APPEAL REF: APP/D1265/W/24/3348224

KNOLL HOUSE HOTEL, FERRY ROAD, STUDLAND, SWANAGE, BH19 3AH

**PROOF OF EVIDENCE OF SAM WILLIAMS,
LEAD SENIOR ECOLOGIST**

Figure 2 – Figure 7 of the Light Spill Mitigation Report with area of light spill >0.5 lux circled in red.

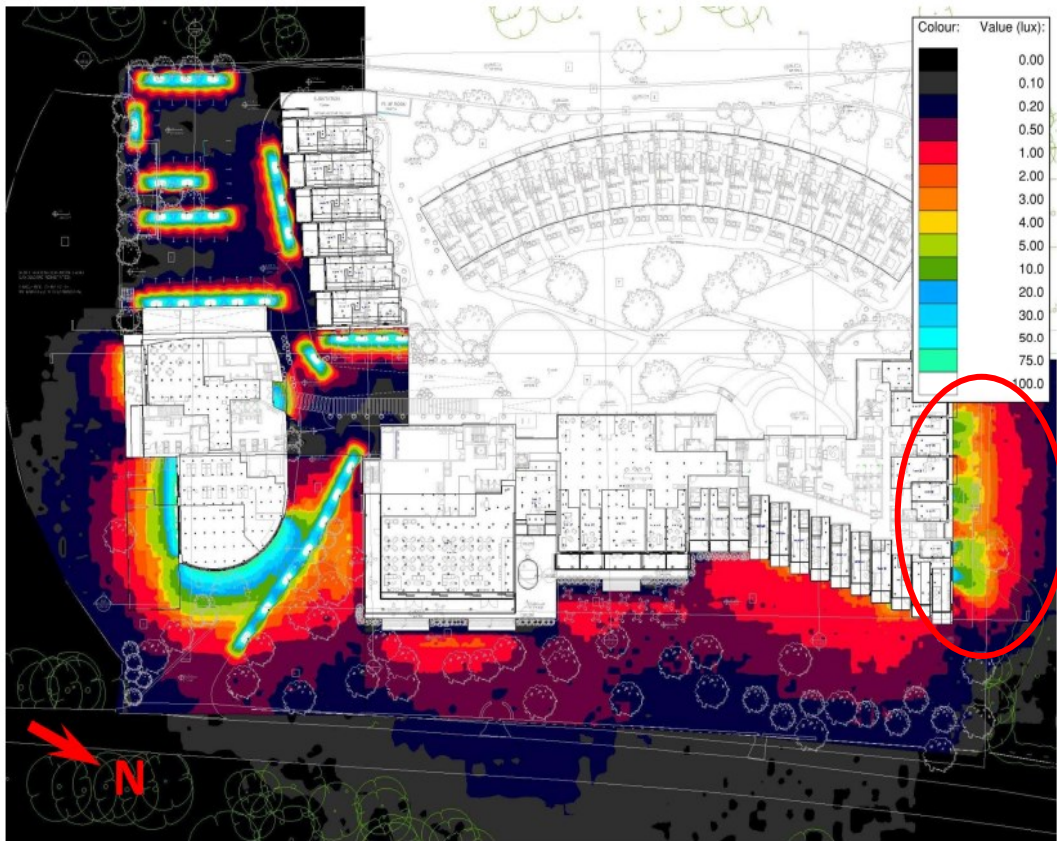
- 4.5 Where Figure 7 of the Light Spill Mitigation Report does present lux plots it demonstrates light spill from the northern elevation of the four-storey apartment building, located in the north of the site, which extends into the 'Dark Corridors' identified in the Biodiversity Plan prepared by Ecology Solutions. That is 'Dark Corridors' which I previously considered to be acceptable in terms of the habitats that they applied. The location of the light spill is shown circled in Figure 2 below, and the 'Dark Corridors' as presented in the Ecology Solution BP are shown in Figure 3. Light levels in the circled location are greater than 0.5lux, extending up to 3/4lux (presented in Figure 7 of the Light Spill Mitigation Report

as yellow and orange), and therefore greater than the acceptable levels established in paragraph 3.7 of this Proof of Evidence. As such, I consider light spill onto this area of woodland to be unacceptable.
